ADDENDUM NUMBER 3

INVITATION TO BID
21-014
ROBERTS DRIVE SIDEWALK PROJECT TS171

SPECIAL CONSTRUCTION DETAIL			
ROBERTS DRIVE SIDEWALK			
FENCING DETAILS			
CHECKED:	DATE:	DRAWING No.	
BACKCHECKED:	DATE:	38-0003	
CORRECTED:	DATE:		
VERIFIED:	DATE:

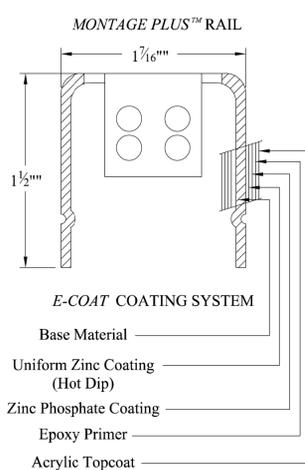
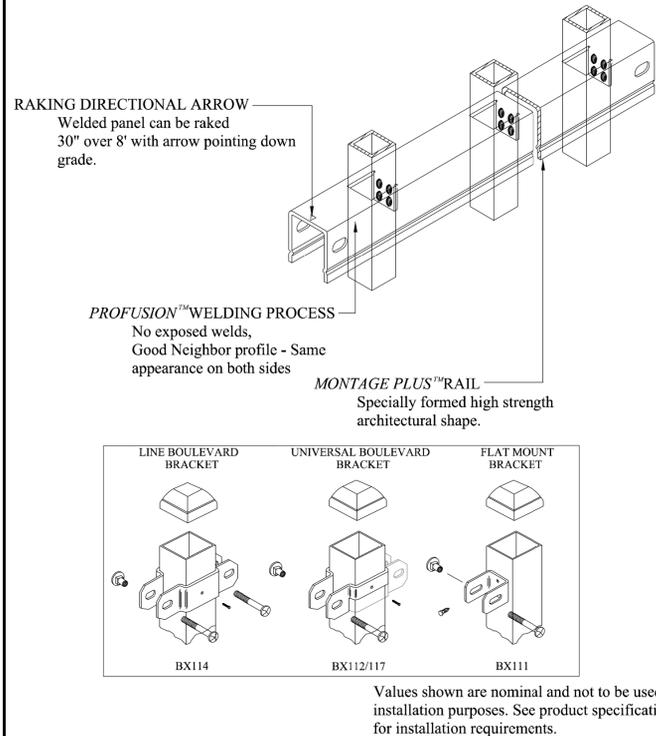
This sheet replaces the sheet 38-0003 in the set

- NOTES:**
1. THE PEDESTRIAN RAILING AND THE MEANS OF ATTACHMENT TO THE TURNDOWN SIDEWALK SHOULD BE DESIGNED PER SECTION 13.8 OF THE AASHTO LRFD SPECIFICATIONS, 7TH EDITION, 2014. CONTRACTOR TO PROVIDE SHOP DRAWING FOR POST ANCHORING. SEE PLAN SHEET 13-0001 FOR LOCATION.
 2. STYLE AND PANEL OPTION AT THE DISCRETION OF THE CITY OF SANDY SPRINGS.
 3. AN EQUIVALENT PRODUCT MAY BE SUBMITTED FOR APPROVAL BY THE ENGINEER.
 4. PANEL HEIGHT AND POST SPACING TO MATCH EXISTING WROUGHT IRON FENCE AS SHOWN ON PARCEL 1 DAVIS ACADEMY (4' HEIGHT X 8' LONG).
